Form 3160-5 (June 2015)

DECISION & CORRECTIVE ACTION IN RESPONSE TO NOWO 18MB067W & AMENDMENT TO THE APPROVED CTB, OLM, SALES & STORAGE ON 01/10/2015

Devon Energy Production Co. Rigel 20 Fed Com 3H, 4H, 6H 3001539725, 3001539726, 3001541513

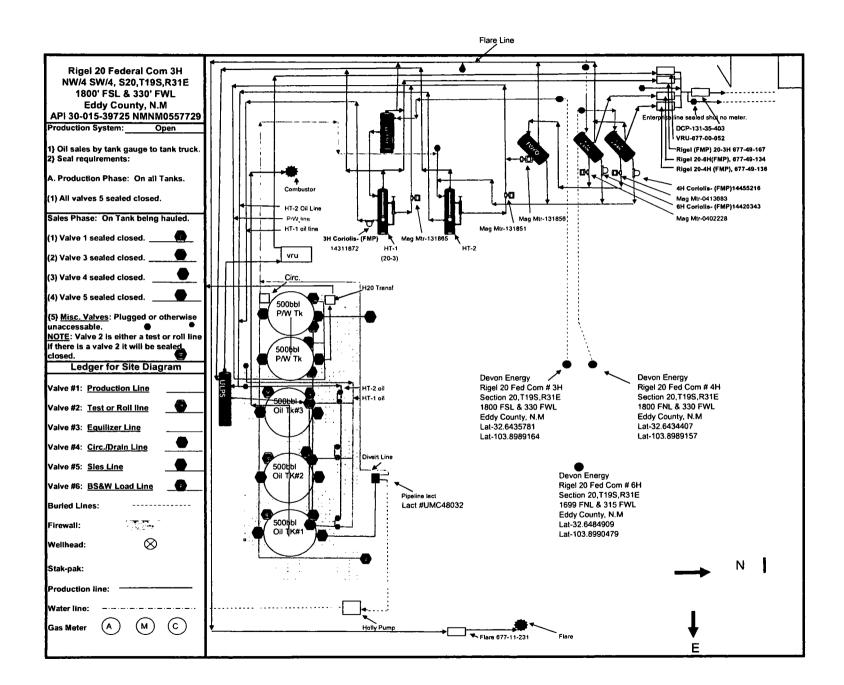
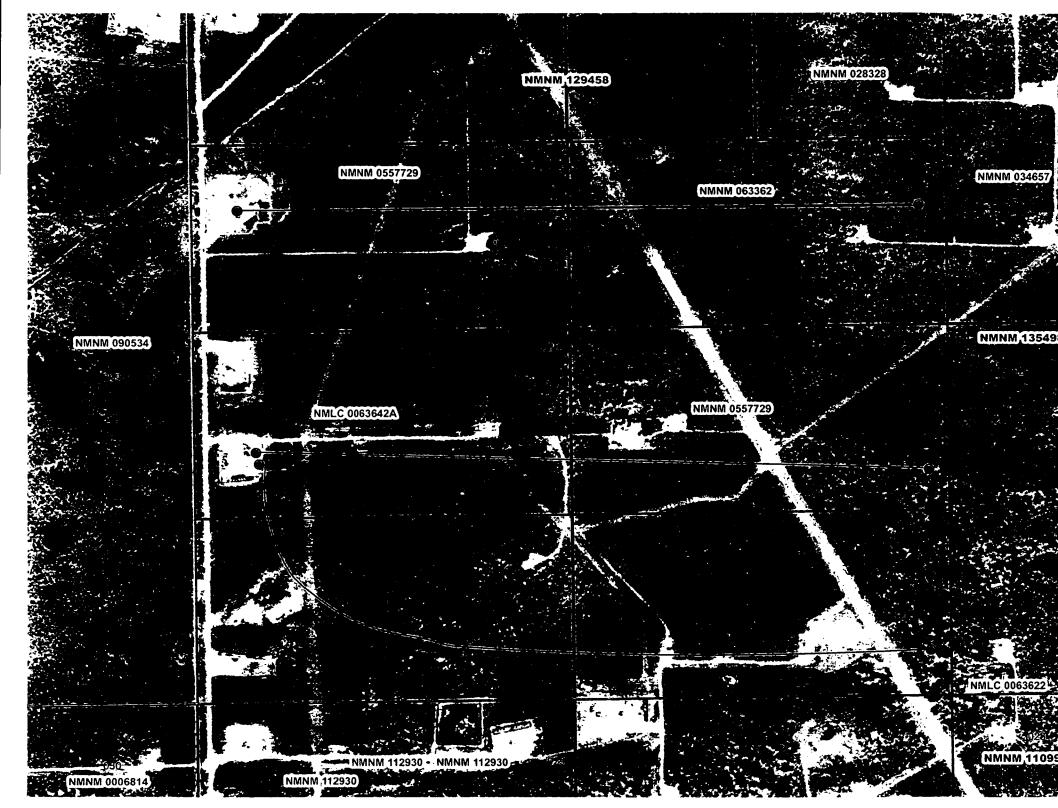
Devon will measure each wells production products (gas, oil & water)individually, so that the commingling issues are resolved at this battery. The VRU production will be allocated back to each well based on the oil production from each well on a monthly basis. Below is the proposed production path, along with the attached updated process flow diagram.

Devon will measure each wells production products (gas, oil, & water) individually, so that the commingling issues are resolved at this battery. The VRU production will be allocated back to each well based on the oil production from each well on a monthly basis. Below is the proposed production path, along with the attached updated process flow diagram.

The Rigel 20 Fed Com 3H production flows into its own two phase separator (2PS-1). After separation, the gas flows to the gas test meter (FMP) #67749167. The produced fluids from the Rigel 20 FC 3H is then routed to its own heater/treater (HT-1) where oil is metered with a Micro Motion Coriolis Meter (FMP) #14311872 after flowing through its own heater/treater (HT-1). The produced water from the Rigel 20 FC 3H is metered utilizing a turbine meter #131865 off the heater/treater (HT-1). Produced water then flows into one of two 500 bbl. water tank on site.

The Rigel 20 Fed Com 4H production flows from the well into its own 3 phase separator located at the Rigel 20 Fed Com 3H facility. Gas exits the 3 phase separator and is routed to the gas test meter (FMP) #67749136. The produced oil exits the 3 phase separator and is metered with a Micro Motion Coriolis Meter (FMP) #14455216 and then flows into the heater/treater (HT-2). The produced water from the Rigel 20 FC 4H is metered utilizing a water mag meter #0413683 off the three phase separator. Produced water then flows into one of two 500 bbl. water tank on site.

The Rigel 20 Fed Com 6H production flows into the Rigel 20 FC 3H facility directly from the 6H's production flow line from the well into its own 3 phase separator located at the Rigel 20 FC 3H facility. Gas exits the 3 phase separator and is routed to the gas test meter (FMP) #6774913. The produced oil exits the 3 phase separator and is metered with a Micro Motion Coriolis Meter (FMP) #14420343 and then flows into the heater/treater (HT-2). The produced water from the Rigel 20 FC 6H is metered utilizing a water mag meter #0402228 off of the 3 phase separator. Produced water then flows into one of two 500 bbl.

Rigel 20 Fed Com 3H associated with CA-NMNM129587 are on CA, Rigel 20 Fed Com 4H associated with CA-NMNM129578 is off CA Rigel 20 Fed Com 6H associated with CA-NMNM129425 is off CA

Approval of off-lease/CA measurement is subject to the following conditions of approval:

- 9. VRU gas will be commingled and allocated back based on oil production as per write-up attached to request. This is also approved, with this approval. Gas vapors normally would be vented or flared.
